STAFF REPORT ADDENDUM

APPLICATION RZ 2013-PR-014

COVER SHEET
CRAVEN PROPERTY
 PROVIDENCE DISTRICT
 FAIRFAX COUNTY, VIRGINIA

RPA AND EQC PLANTING PLAN

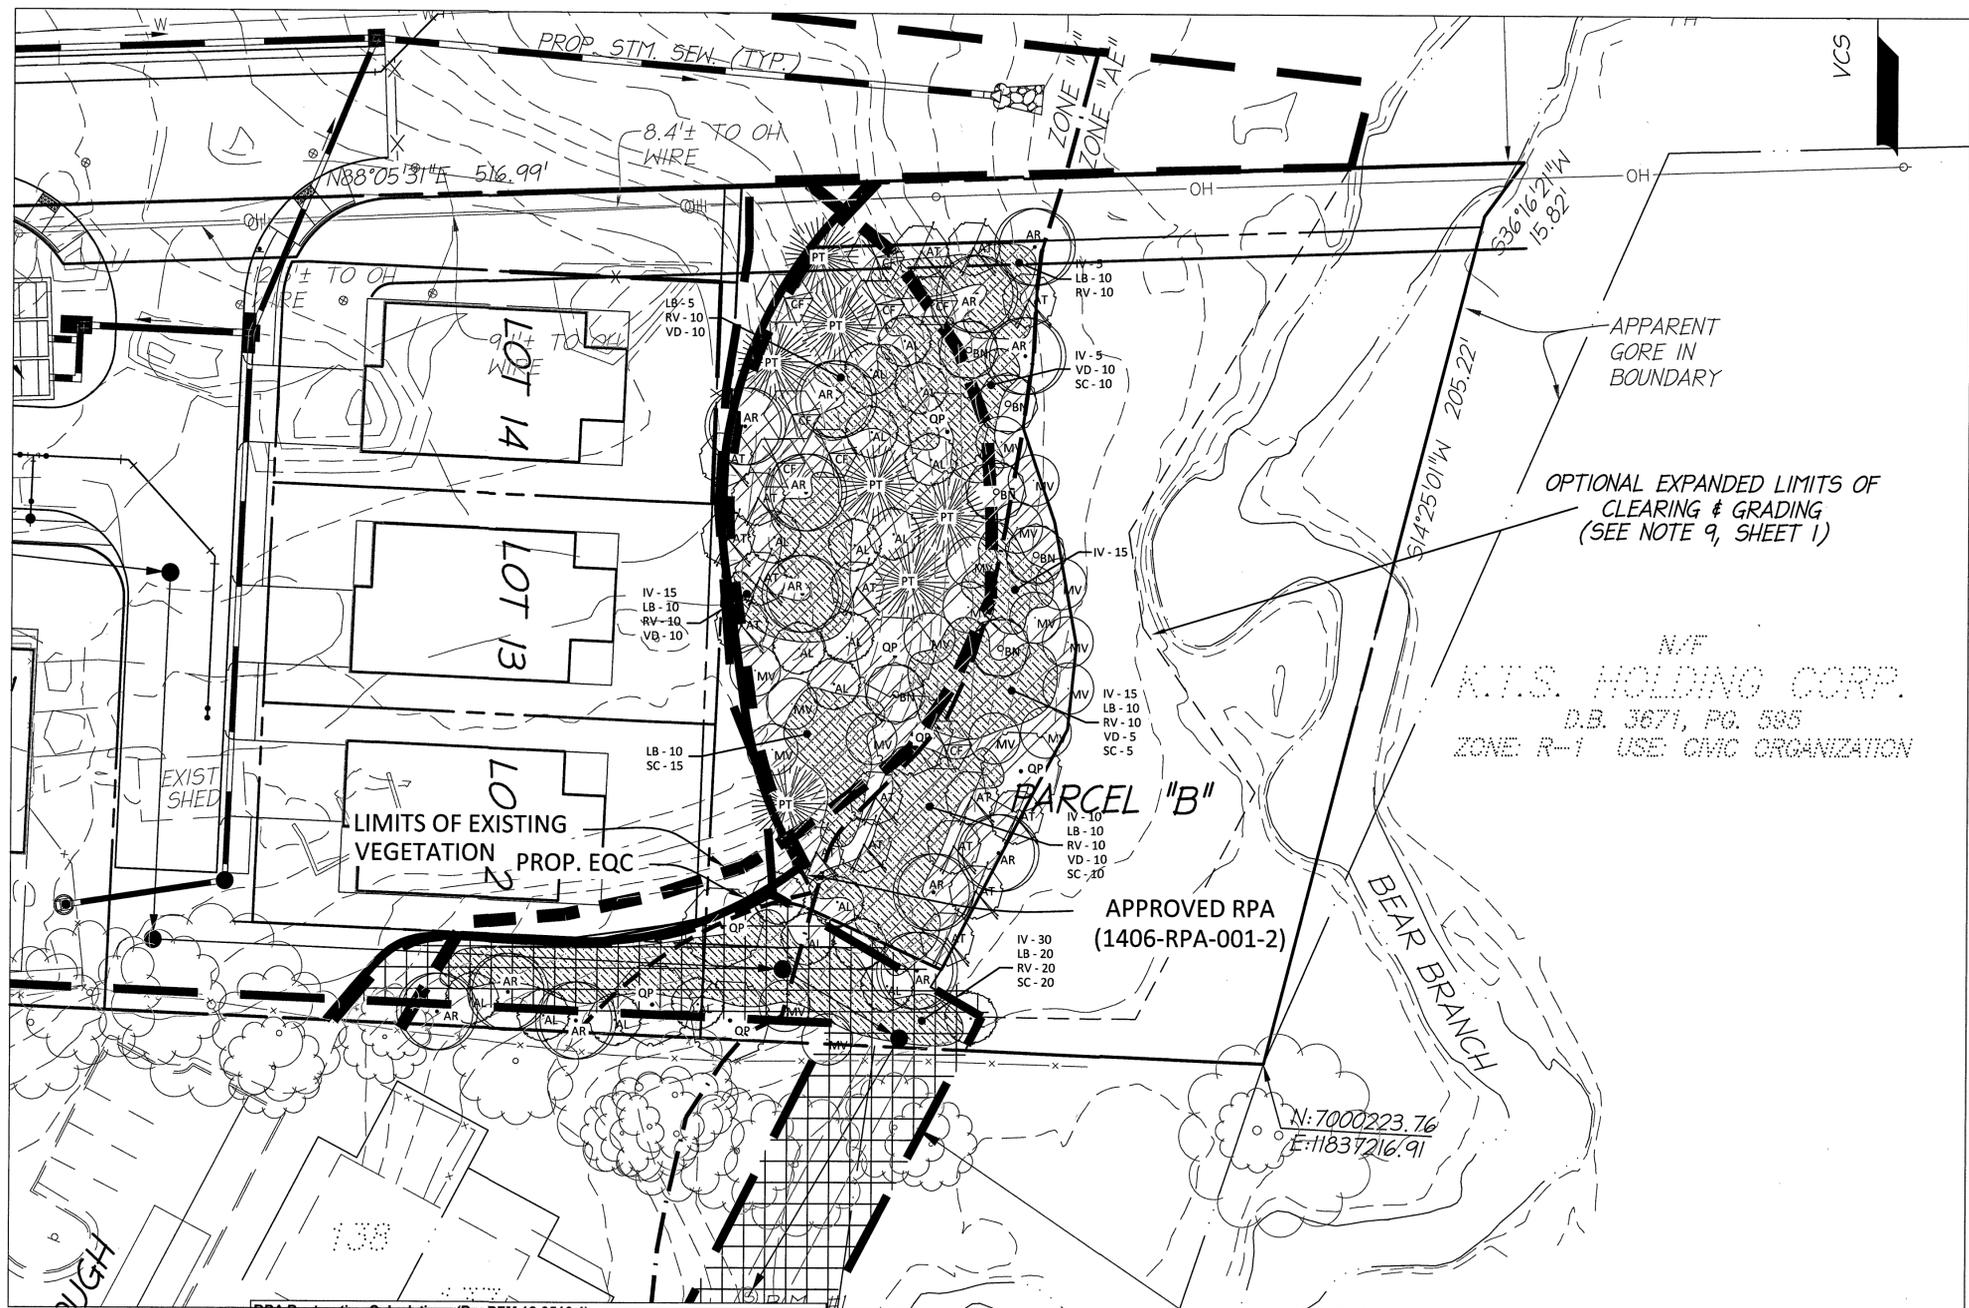
- The planting schedule (Sheet 8) is improved based on prior comments regarding use of non-invasive and native species.
 - Deer protection is necessary for all woody plantings to ensure their growth and survival. Please provide specifications for how plants will be protected from deer browse, particularly in any natural areas to be dedicated to the Park Authority.
 - Include biodegradable bark protection for all 3" caliper trees planted.
- Please confirm that the invasive species management plan (Sheet 8) will be implemented by a certified applicator on property to be dedicated to the Park Authority.
 - A written invasive removal plan to include maps of treatment areas should be developed by a VA certified pesticide applicator with the review of Park

- The native seed mix (Sheet 8, Note 1) applied to disturbed areas on parkland (i.e. outfall) should be fully specified for review by NRMP staff.
 - The native seed mix for this project must be obtained from Ernst Conservation Seeds of Meadville, PA or a Park Authority approved alternate vendor. Bag tags must be provided to the Park Authority.

- Bluestemmed goldenrod – *Solidago caesia* – 3%
- Please reconcile the proposed soil amendment plan (Sheet 8) with the Park Authority's standard recommendations for restoring ground disturbance to parkland. The following recommendations ensure germination and establishment of the native seed mix:

- Include biodegradable bark protection for all 3” caliper trees planted
- Confirm that the invasive species management plan (Sheet 8) will be implemented by a certified applicator on property to be dedicated to the Park Authority

- Commit to specify the native seed mix, using provided references as appropriate, and provide for review by Park Authority staff at time of site plan
- Commit to reconcile the proposed soil amendment plan (Sheet 8) with the Park Authority's standard recommendations for restoring ground disturbance to parkland, using provided references, at time of site plan
- Commit to ensure any easements associated with continued maintenance/use of stormwater features in Parcel B allow the possibility of a trail crossing at some future time
- Note that at the time of site plan, the applicant may be required to gain a construction permit or similar from the Park Authority for clearing, grading, and/or drainage improvements on parkland, depending on the type of existing easements held by the applicant
- Dedicate Parcel B to the Park Authority

Figure 2: Revised Layout

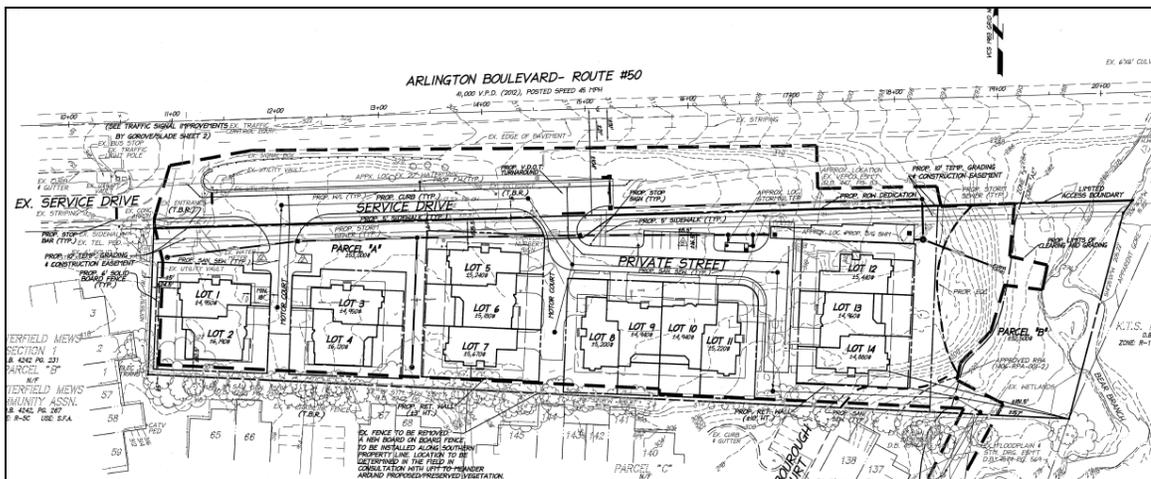
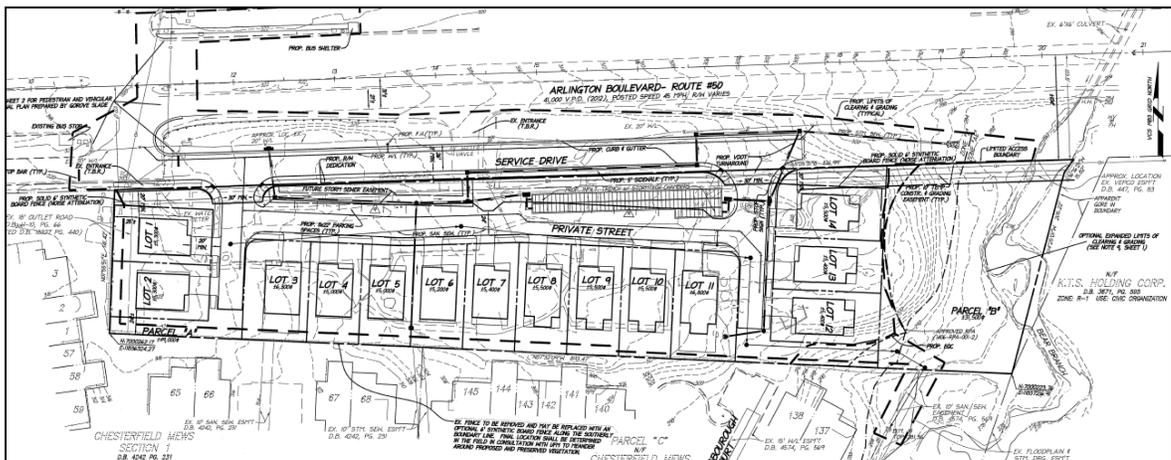
The applicant has revised the GDP, titled "Craven Property," submitted by LDC consisting of 12 sheets dated July 2013 as revised through March 23, 2015. This new GDP proposes 14 single-family detached dwellings and carries forward all of the same positive elements that were worked out during the previous review of the application. In addition, the applicant has improved stormwater management, increased guest parking, and proposed a longer service drive. Figures 1 and 2 below show the previously proposed layout and the revised layout for comparison. A list of the modifications to the existing GDP in order to accommodate the revised layout is also provided below:

- **Layout and Circulation** (Sheets 2 and 3 of the GDP): This revised GDP extends the Arlington Boulevard (Rt. 50) service drive further to the east, with two access points to the proposed development located off of the extended service drive. Three new private streets are proposed within the development. The western private street will extend approximately 120 feet to the south, and the eastern private street will extend approximately 160 feet to the south. The third private street will be approximately 480 feet long and run east-west parallel to the service drive, connecting the two shorter private streets. The combination of the service drive and the three private streets will create a loop for the development. Staff views this layout as a more logical circulation pattern than that of the previous single-family attached proposal, which proposed two non-connected private streets located off of a shorter service drive. Two lots will be located on the western side of the western private street, three lots will be located on the eastern side of the eastern private street, and nine lots will be located on the southern side of the longer east-west private street.

- **Unit Type** (Sheets 1, 2 and 12 of the GDP): This revision proposes single-family detached dwellings as opposed to the previously proposed single-family attached dwellings. The proposed lots average approximately 5,507 square feet in area. All dwellings will have a minimum 20-foot front yard setback, an 8-foot side yard setback, and a 25-foot rear yard setback, which meet the regulations of the R-5 District. The applicant is requesting a modification for the minimum lot width for Lots 3 and 11 from a minimum of 70 feet to 64 feet. Staff has no objection to this modification. Architectural elevations are included in the revised GDP.

- **Traffic Improvements** (Sheets 2 and 3 of the GDP): The revised GDP shows modified traffic improvements at the intersection of Arlington Boulevard and Covington Street, including the relocation of the mast arm traffic signal pole, guardrail relocation, traffic control boxes, traffic signal loops, median adjustment for pedestrian crosswalk, and stop signs and stop bars on the service drive. In addition, the GDP shows a proposed bus shelter on the north side of Arlington Boulevard. These improvements are proposed instead of installing a third eastbound lane of Arlington Boulevard along the application site. No funds for future construction of
